# UNITED STATES PATENT AND TRADEMARK OFFICE

10/551,056

<b>Office Action Summary</b>	<b>Application No.</b> 10/551,056	<b>Applicant(s)</b> SHEZIFI ET AL.	
	<b>Examiner</b> LYNNSY SCHNEIDER	<b>Art Unit</b> 3733

## **DETAILED ACTION**

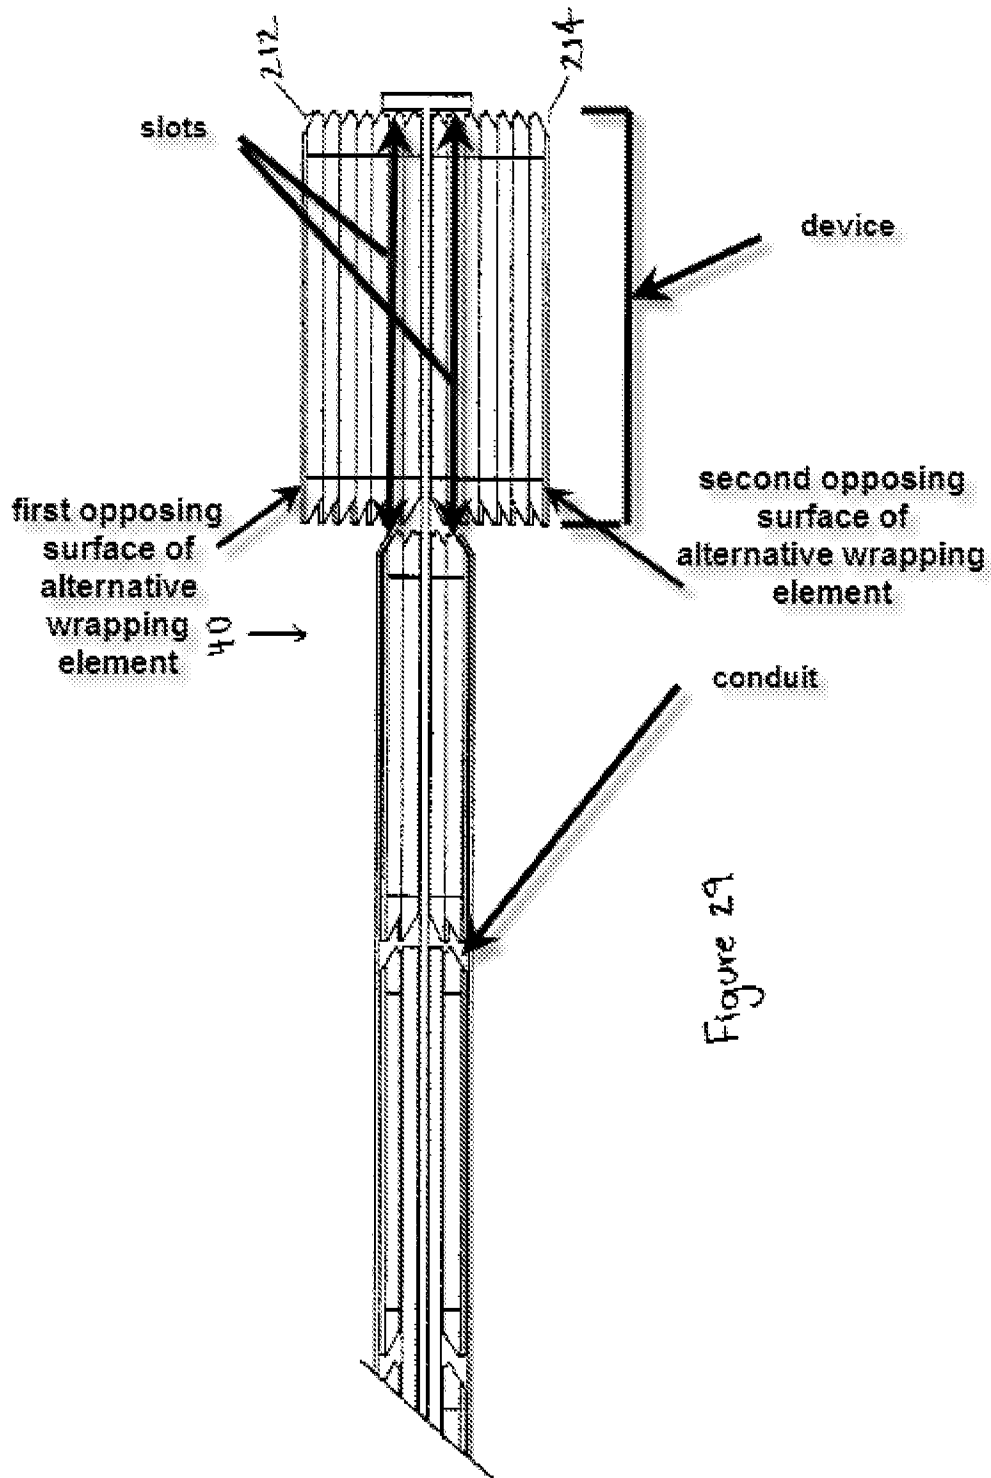
Regarding claims 1, 9, 14, 29, 30, and 31, Johnson et al. discloses a device (figure 29) for distracting and supporting two substantially opposing tissue surfaces in a patient's body, the device comprising: a wrapping element (paragraph 0177 "permeable

membrane”); an expandable structure “wafers” insertable between two opposing support surfaces of the wrapping element, and adapted to be expanded between the two substantially opposing tissue surfaces to a predetermined dimension (figure 29); and an introduction member 40 (figure 29), the introduction member 40 comprising a substantially linear conduit (figure 29), having a proximal end through which the expandable structure is inserted and a distal end having two substantially opposite slots (figure 29) through which the expandable structure deploys in directions substantially perpendicular to the conduit (figure 29), wherein the implant device is adapted to remain implanted in its entirety in the patient’s body (Paragraphs 0031, 0035 disclose that the wafers and insertion device are each adapted to remain in the body. Although Johnson does not explicitly disclose the device in its entirety remaining implanted in the body, the device is adapted to remain implanted in its entirety since each of the wafers, wrapping element, and introduction member are adapted to remain implanted). The expandable structure comprises a segmented strip (figures 32 and 33) made of a series of jointed segments 220 pivotally interconnected (via tethers 218) so as to present a multi-joint strip, each segment having an elongated bore “holes” provided on it through which a fastener “bone filler” may be interlaced, for holding the strip in a folded state of a desired height (paragraph 0128). The expandable structure comprises two foldable straps placed on either sides of a bar (figure 29 discloses two separate wafer stacks, and paragraph 0132 discloses that the wafers can be tethered. The tethered wafers form a foldable strap. Therefore, each wafer column comprises a foldable strap.) The wrapping is incorporated with the expandable structure (paragraph 0177). The
